Recall Bulletin

PRODUCT SAFETY RECALL

SUBJECT: Transmission Turbine Shaft Fracture

MODELS: 2012 Chevrolet Sonic
With 6 Speed Automatic Transmission (Model 6T30 - RPO MH9)
And 1.8L Engine (RPO LUW)

Proper Alignment of the (543) Low and Reverse Clutch Assembly (Zoomed In Below)

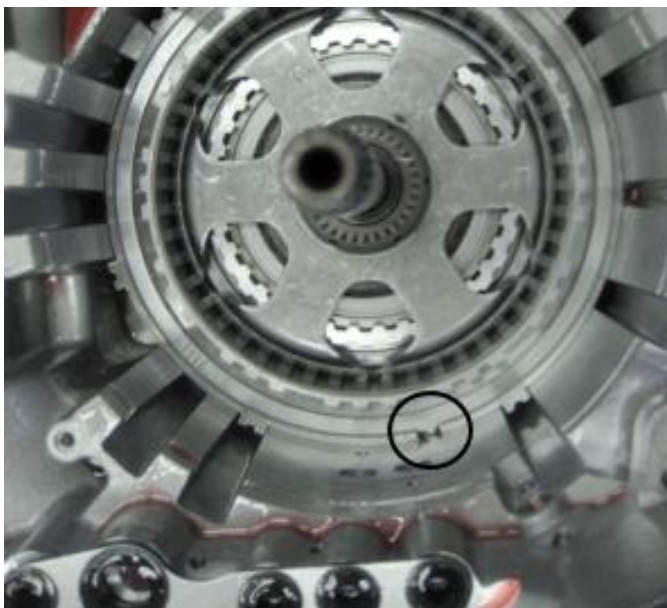
Installation procedures in SI. Also note the photos below that show proper alignment of the (543) Low and Reverse Clutch Assembly to prevent incorrect installation and transmission damage. It is also recommended that GM technicians log on to <https://www.centerlearning.com/> and view a related training video that is found at the 40 minute mark of 10214.07D July 2014 Emerging Issues Seminar by following this path: *Resources>> Video on Demand>> Enter 10214.07D in the “Search Videos” Field >> Click on the Magnifying Glass Icon to search for the video.* For Canada technicians, this video can be viewed on the GM Centre of Learning (LMS) web site, which can be accessed via the Single Sign-on process through Global Connect. Click on the “Resources” menu option, and then select “Video on Demand,” “GM Pro – Centre of Learning” and “Service Technical.” The video will be in the list displayed on the page.
